Access Compliance Report

Public Rights-of-Way

(Curb Ramps)

Intersection ID: 50582	Main Street: DOWNY_BIRCH_RD	Cross Street: PAPER_TREE_RD	Location: NE
ADA ID: 5C2FBB5409E9	Ramp Type: BlendTrans1	Initial Pass/Fail: Fail	Overall Compliance: No
Severity Score: 21.25			
Codes/Mitigation Info/Possible Solution		Field Measurements/Component Compliance

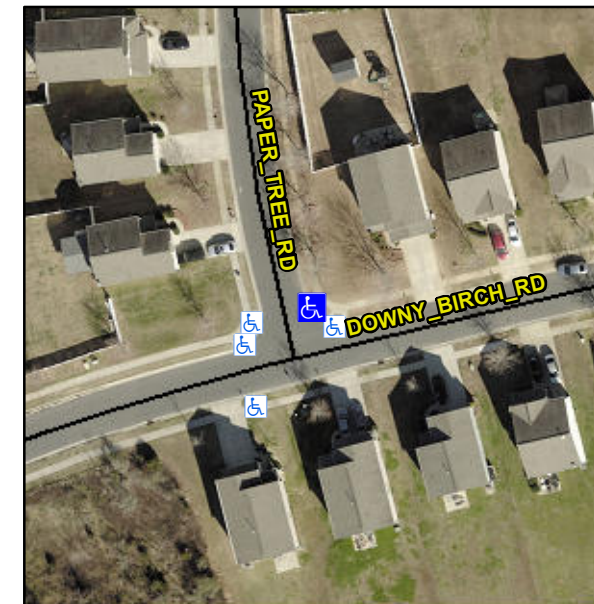
CURB GAP 1.0

Not Found, R304.5.1, R304.5.3

Compliance	Description	Data	Compliance	Description	Data
N/A	Ramp Length (in)	46.5	Yes	BlendTrans Slope (%)	0.1
No	Ramp Width (in)	47.5	No	BlendTrans XSlope (%)	6.7
N/A	Flare Type LT	N/A	N/A	Flare Type RT	N/A
N/A	Flare Slope LT (%)	N/A	N/A	Flare Slope RT (%)	N/A
N/A	Flare Traversable LT?	N/A	N/A	Flare Traversable RT?	N/A
N/A	Landing Length (in)	N/A	N/A	DWS Provided?	N/A
N/A	Landing Width (in)	N/A	N/A	DWS Contrast?	N/A
N/A	Landing Slope (%)	N/A	N/A	DWS Length (in)	N/A
N/A	Landing X Slope (%)	N/A	N/A	DWS Full Width?	N/A
N/A	Landing Curb? (Y/N)	N/A	N/A	DWS Offset (in)	N/A
N/A	Shared Landing?	N/A			
N/A	Gutter Ponding?	N/A	N/A	Gutter Slope (%)	N/A
N/A	Gutter Lip Ht (in)	N/A	N/A	Gutter X Slope (%)	N/A
N/A	Painted X Walk1?	No	N/A	Painted X Walk2?	N/A
	X Walk 1 Direction	To W		X Walk 2 Direction	N/A
	X Walk 1 Width (in)	N/A		X Walk 2 Width (in)	N/A
	X Walk 1 Slope (%)	0.6		X Walk 2 Slope (%)	N/A
	X Walk 1 X Slope (%)	4.8		X Walk 2 X Slope (%)	N/A

N/A	Ramp inside XWalk1?	N/A	N/A	Ramp inside XWalk2?	N/A
	Road Slope (%)	4.8		Clear Space?	N/A
	Road X Slope (%)	0.6	N/A	Clear Space to XWalk (in)	N/A
N/A	Any Obstructions?	N/A	N/A	Storm Grate/Utility Hazard?	N/A
	Obstruction Type			Storm Grate/Utility Type	
		N/A			N/A
			Yes	Surface Condition? (G/P)	Good
			No	Curb Slope (%)	14.3

Remove & Replace Curb Ramp With Two New Directional Ramps or Equivalent.
